Planning Officer's Report - LDCA October 2019

APPLICATION	2019/47 – Proposed Conversion: Bungalow to Split Level
PERMISSION SOUGHT	Permission in Full
REGISTERED	11 June 2019
APPLICANT	Madolyn Andrews
PARCEL	BG0251
SIZE	0.16 acres
LOCALITY	Barren Ground
LAND OWNER	Madolyn Andrews
ZONE	Intermediate Zone
CONSERVATION AREA	None
CURRENT USE	Existing three room house
PUBLICITY	The application was advertised as follows: <ul style="list-style-type: none">▪ Independent Newspaper on 14 June 2019▪ A site notice displayed in accordance with Regulations.
EXPIRY	28 June 2019
REPRESENTATIONS	None Received
DECISION ROUTE	Delegated / LDCA / EXCO

Diagram 2: Site Plan

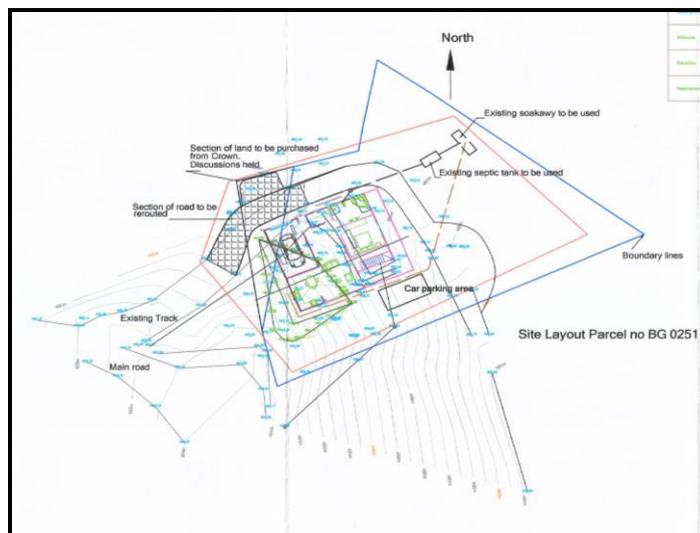
- 1.5 While there is an existing access track from the main road to the site, because of the position of the proposed development a section of new access road is required to be excavated. This section of new road will also fall within the additional land that is required from Crown Estates.

Diagram 3: Site Section

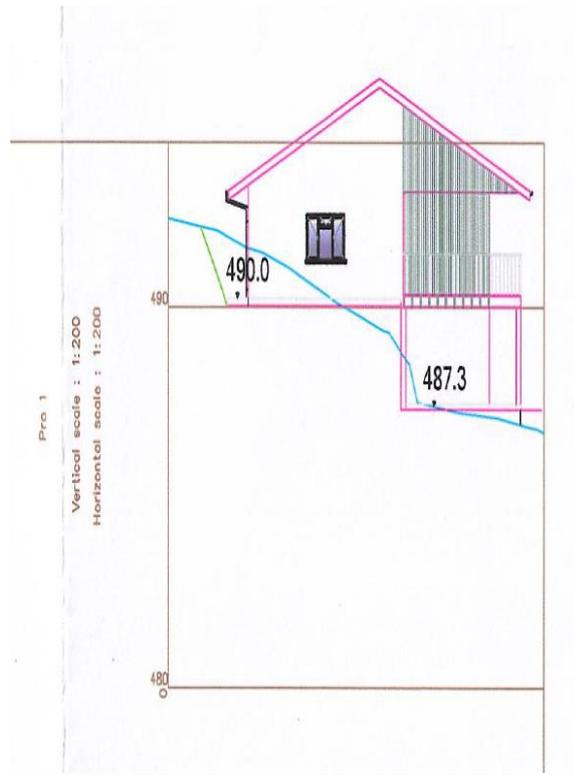
- 1.6 As seen from the site section drawing below, excavation is minimal with the highest level of embankment (3.3 metres) in the south west corner.

Diagram 4: Existing House

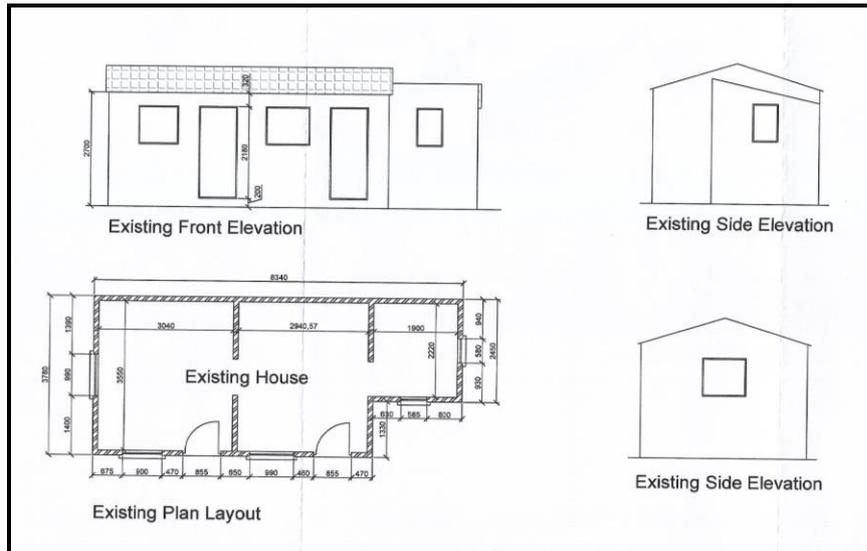
- 2.1 The existing three bedroom bungalow is a 450x225x100mm concrete blockwork structure. The foundations and walls do not have the structural strength to allow a concrete floor and concrete blockwork wall structure above.

- 2.2 The smaller room on the north corner will be extended to create a square building to allow for the support of the first floor floor-joist and subsequent first floor extension.

- 2.3 A 450x225x225mm reinforced concrete blockwork retaining wall to be built behind the existing building as support to the first floor extension which will also render protection to the existing building.

- 2.4 Existing Roof structure and asbestos roof covering to be removed (see point No. 14 under heading: **“RECOMMENDATION”** below for best practise on correct asbestos removal and disposal). Top of gable walls to be demolished to create a level structure to receive the timber floor joist.
